Spreeukloof Wind Energy Facility, Eastern Cape Province

Motivation for amendment of Environmental
Authorisation

DEA Ref.: 12/12/20/1778/5

July 2021

Figure 5.5: Comparative Viewshed Analysis for Spreeukloof Wind Farm

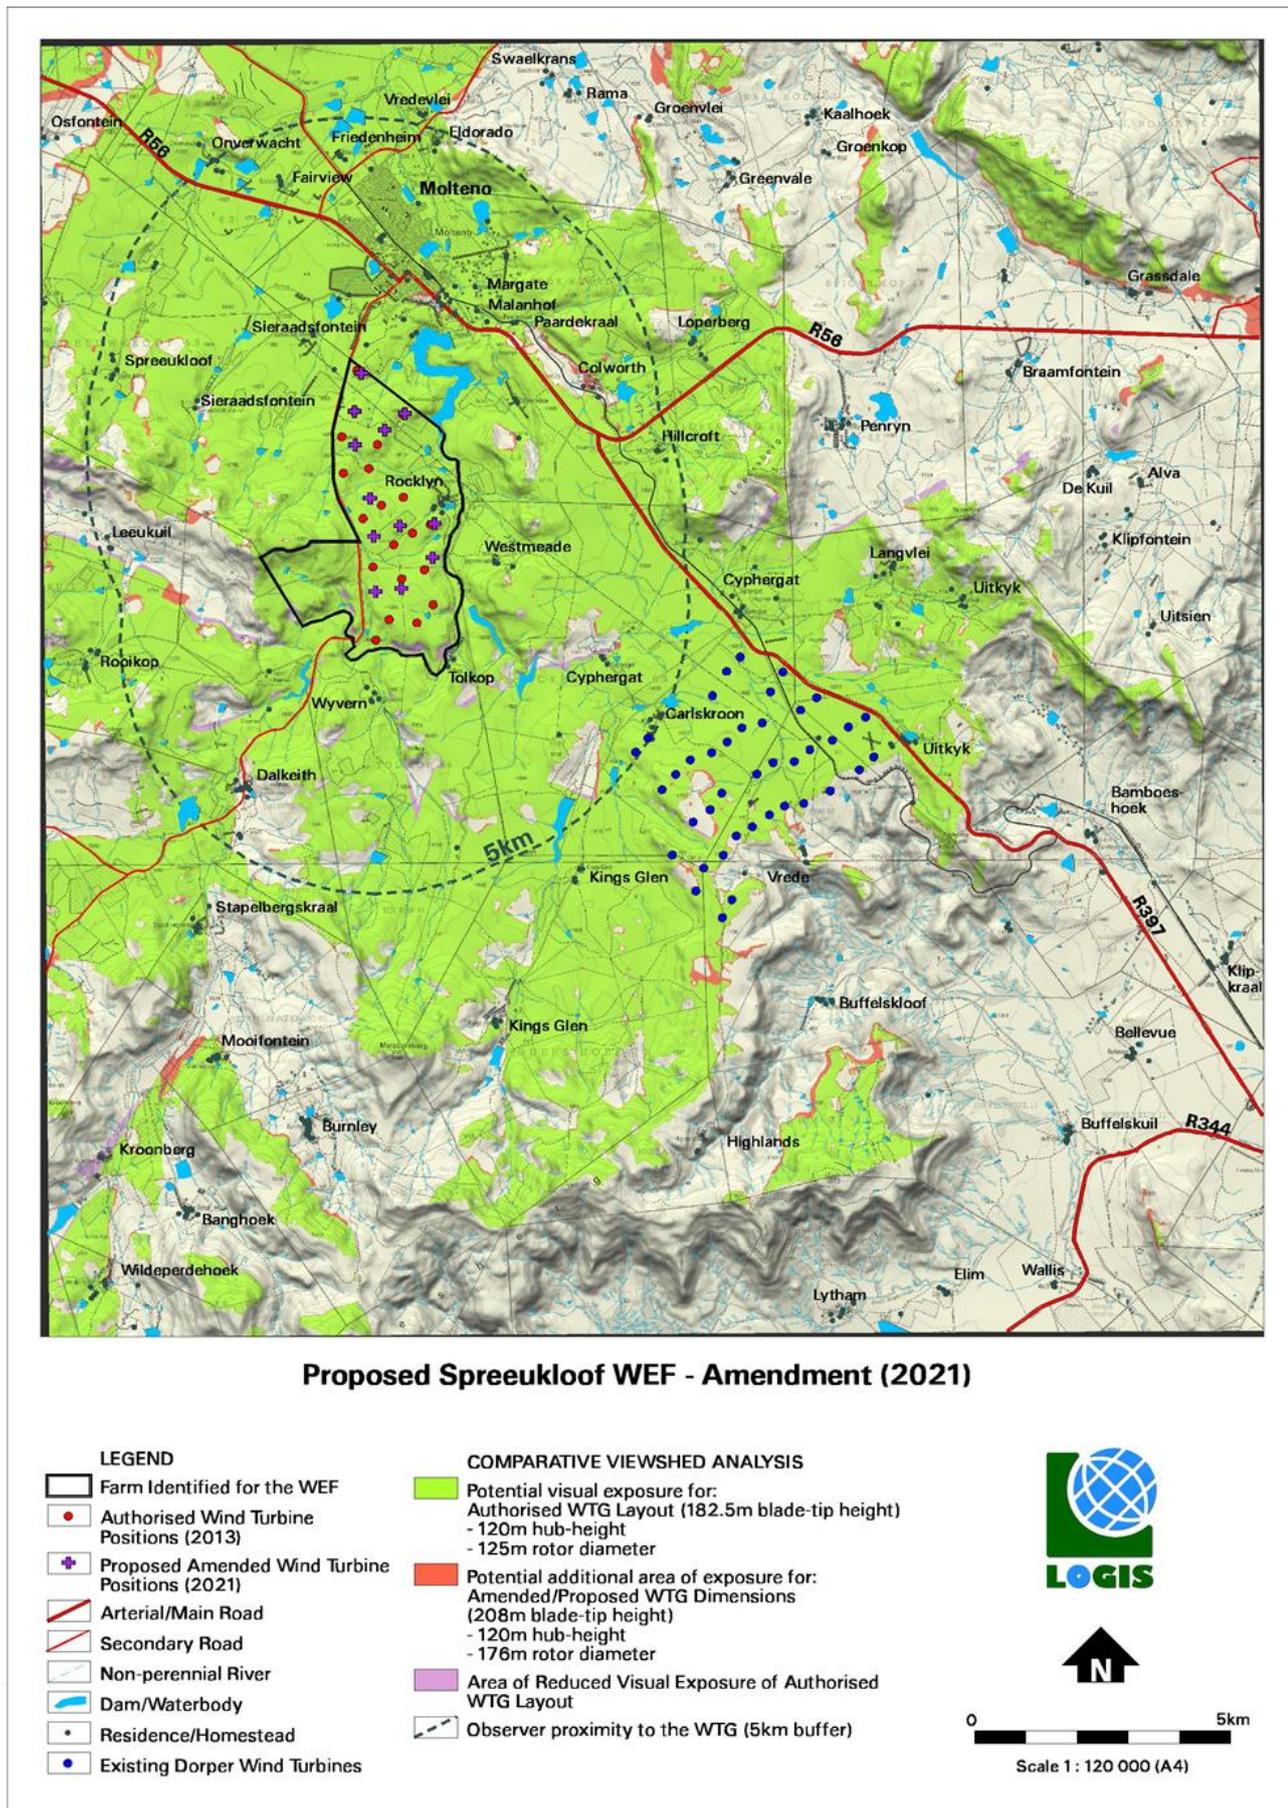
A viewshed analysis was undertaken (**Figure 5.4**) from each of the authorised wind turbine positions (21 in total) at an offset of 182.5m (maximum tip height) above ground level. The result of this analysis represents the potential total visual exposure of the original and authorised turbine dimensions (indicated in green and purple on **Figure 5.4**). The viewshed analysis was repeated at an offset of 208m to indicate the visual exposure (shown in red) of the increased turbine dimensions and reduced number of turbines (9 in total)

The analysis indicated that with the proposed amendments, approximately 12% increase in turbine dimensions, would have a relatively small influence on the overall visual exposure, due to the already tall turbine structures previously approved and the elevated positions of the turbines within the landscape. The surface area (within the study area) of the original turbine exposure is 274km², compared to the 277km² of the increased dimensions of the wind turbine exposure. This is an increase of 3km², or alternatively, an increase of less than 1% in potential visual exposure. It should be noted that the above calculation includes an area of 4km² that represents the surface area that won't be visually exposed after the reduction in the number of wind turbines.
